# Product Change Notification

## 113788 - 00

**Change Notification #:** 113788 - 00  
**Change Title:** Intel® Server System P4304CR2LFKN  
PCN 113788-00  
Product Design, Label  
Update Hard Disk Drive Tray to add 2 latches and labels, and Update the Safety label with an EAC logo instead of a GOST logo  
**Date of Publication:** April 14, 2015

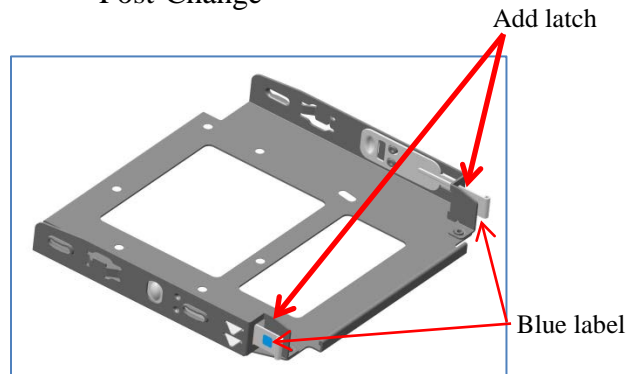
1. Add two latches and labels for the fixed HDD (Hard Disk Drive) tray to enhance the robustness of the HDD tray and indicate the touch point for the HDD tray assembly.
